DOCKETED	
Docket Number:	19-BSTD-03
Project Title:	2022 Energy Code Pre-Rulemaking
TN #:	235280
Document Title:	Home Ventilating Institute Comments - HVI Comment - Docket No 19-BSTD-03, 2022 Energy Code Pre-Rulemaking, October 16, 2020
Description:	N/A
Filer:	System
Organization:	Home Ventilating Institute
Submitter Role:	Public
Submission Date:	10/16/2020 10:47:34 AM
Docketed Date:	10/16/2020

# HVI Comment - Docket No 19-BSTD-03, 2022 Energy Code Pre-Rulemaking, October 16, 2020

Re: Docket No. 19-BSTD-03, 2022 Energy Code Pre-Rulemaking

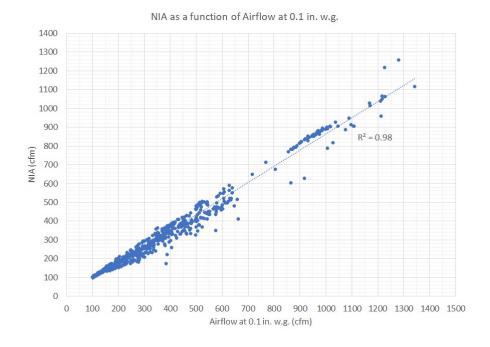
The rating metric that provides the closest approximation of a range hood's actual airflow is NIA. NIA is calculated from the intersection of a range hood's fan curve and a system curve that is considered "typical" (i.e., 10 feet of smooth duct, two elbows, a termination fitting, and a duct diameter that is equivalent to the range hood's duct take-off). Therefore, HVI proposes that the 200 cfm proxy be an NIA rating. Because the NIA rating is relatively new, HVI proposes that CEC also permit a rated airflow at 0.1 in. w.g. for demonstrating compliance. An analysis of over 700 rating points for range hoods listed in HVI's Certified Product Database suggests that an airflow rating of 230 cfm at 0.1 in. w.g. is a reasonable proxy for an NIA of 200 cfm. See Figure 1.

- iii. a rated airflow no less than 230 cfm at 0.1 in. w.g, or
      - iv. a rated airflow no less than 200 cfm at 0.1 in. w.g. and an installed airflow no less than 200 cfm as verified by a HERS rater.
